June 4, 2019

To: Architectural Review Board

Re: Meeting – June 16, 2020

411 West Campbell Street  
Special Capital Historic District

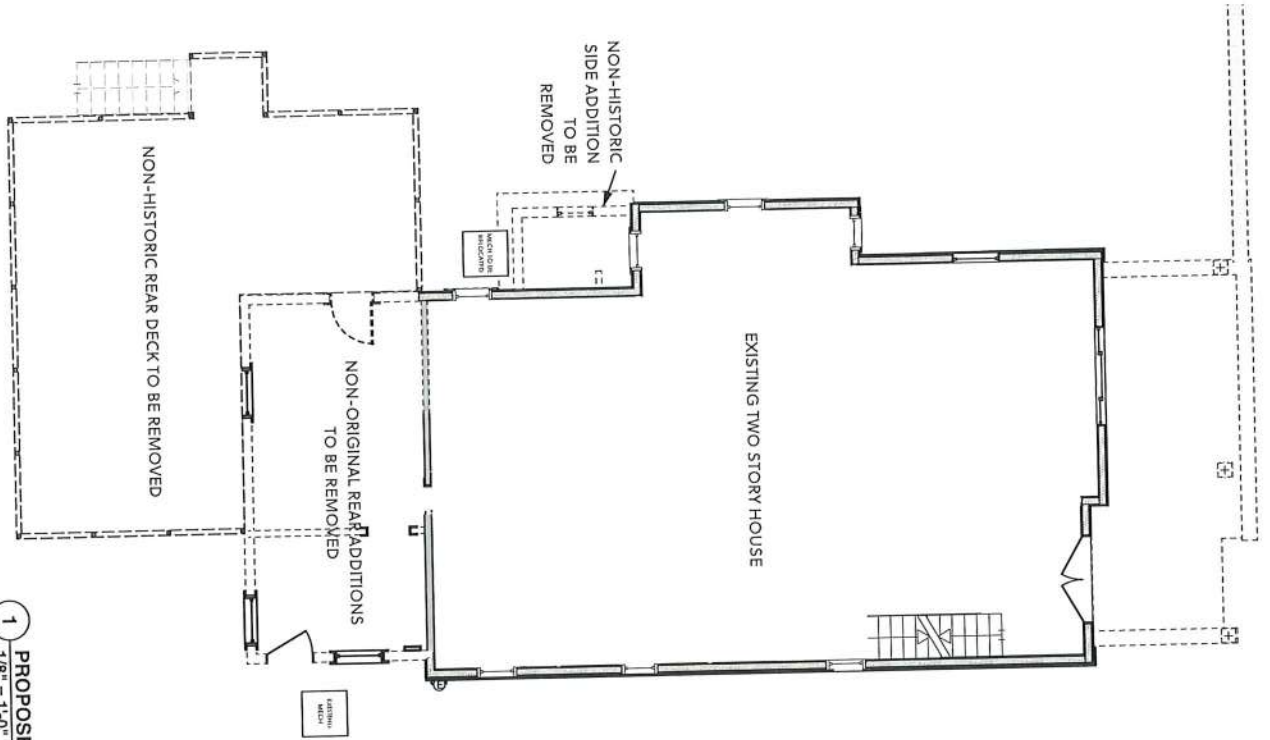
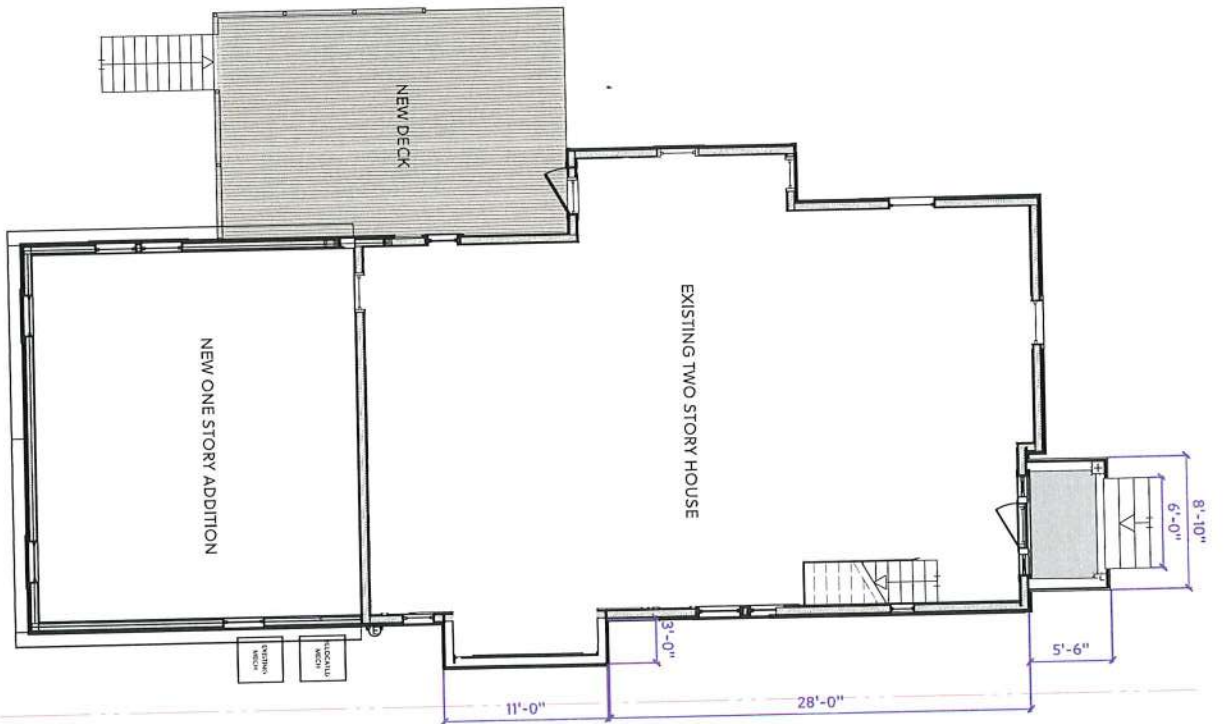
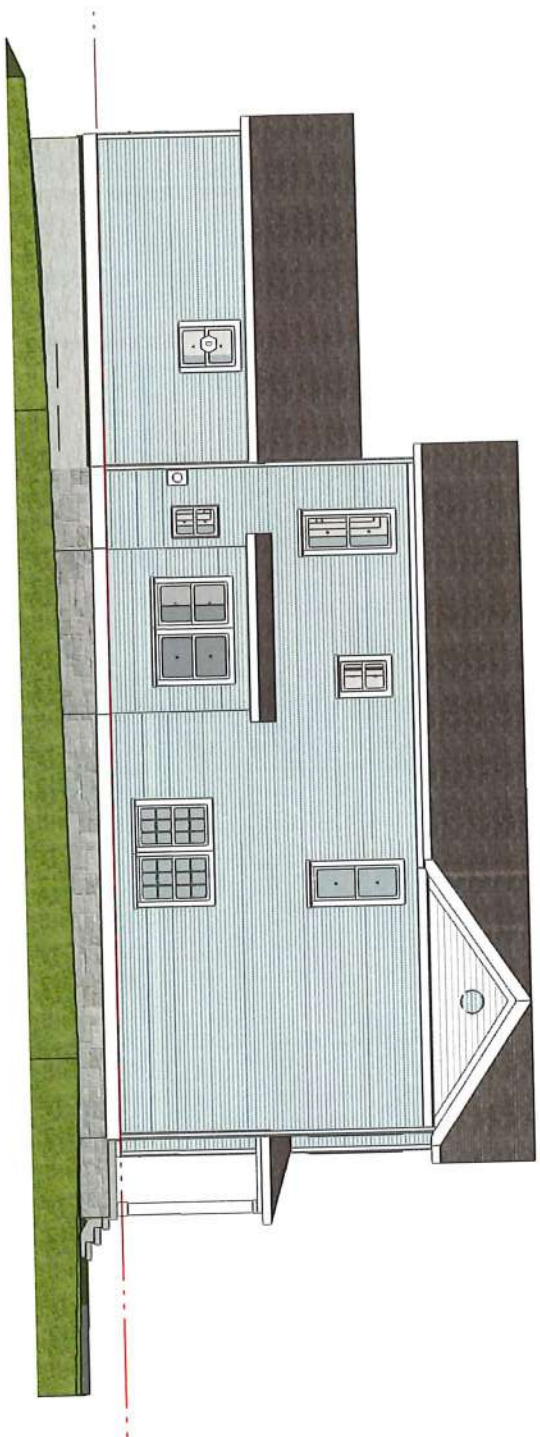
Staff finding: Positive. The proposed front porch is an improvement over the existing front porch and its design is compatible with the architecture of the structure. The removal of the existing porch will expose more of the historic façade of the building and the proposed smaller porch is more complimentary of the scale and massing of the structure.

1. A building permit shall be obtained prior to work commencing on the proposed project.
2. Any additional projects requiring a building permit shall require review and approval by the Architectural Review Board unless a Certificate of No Exterior Effect is issued.
3. All exterior work conducted as a part of this approval shall conform to the design and drawings contained within this report.
